## **BID NUMBER #23041**

**Project: Gages Lake Road Elevated Tank**

**Subject: Addendum #1**

**Date: September 8, 2023**

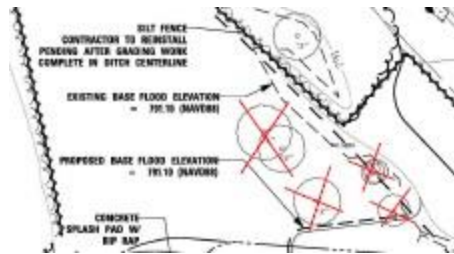
24. Can a Cash Allowance be established for Bid Item 12?

**Answer: Item 12 is a lump sum price.**

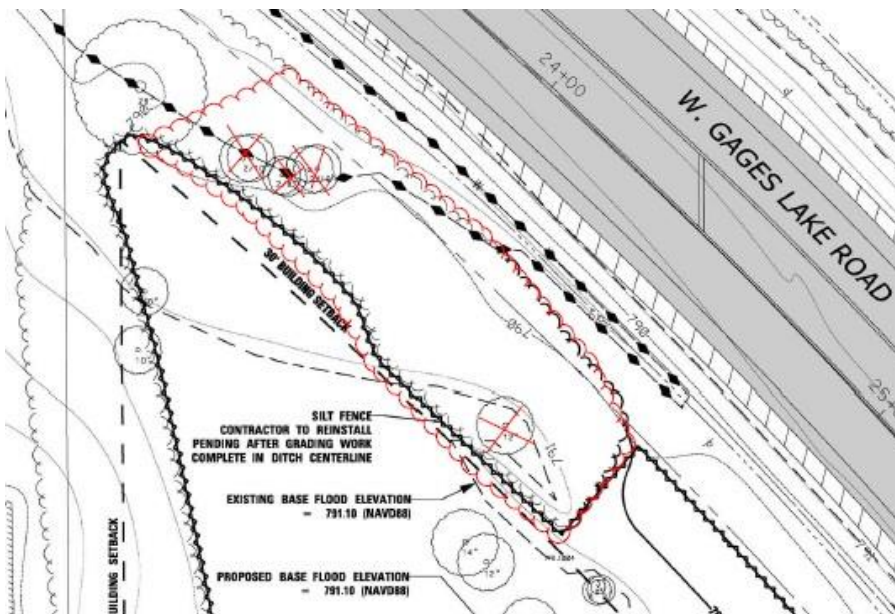
27. Drawing 3 – we will require addition room beyond what is shown. Please confirm the trees and shrubs in this area can be removed.

**Answer: Answer: Shrubs in the area may be removed. Trees in the area might be able to be removed based on owner's approval.**

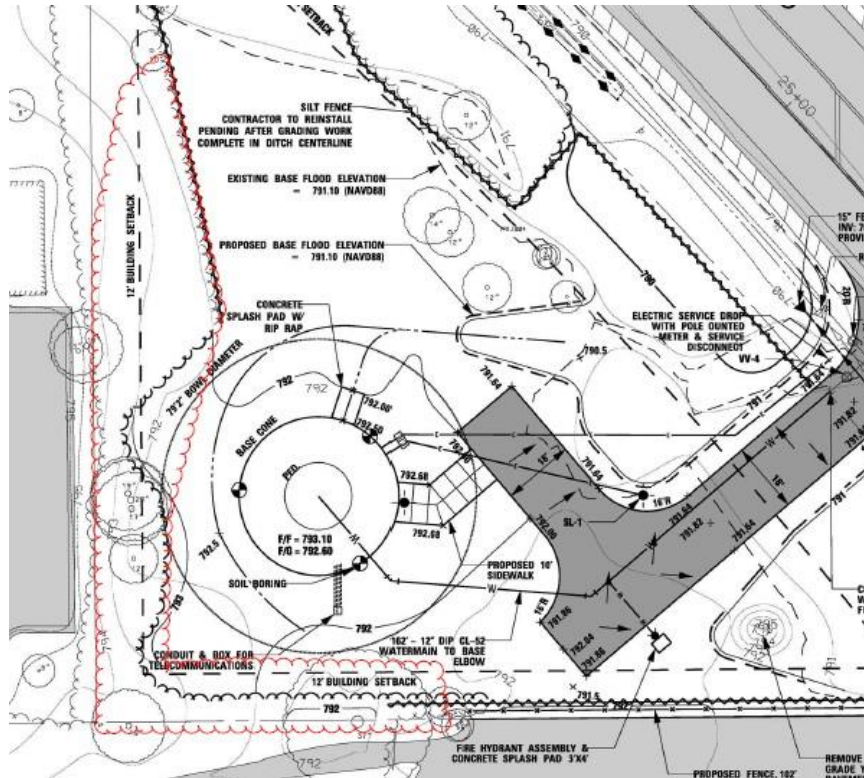
28. Drawing 3 - we will require addition room beyond what is shown. Please confirm the trees and shrubs in this area can be removed.

**Answer: Shrubs in the area may be removed. Trees in the area might be able to be removed based on owner's approval.**
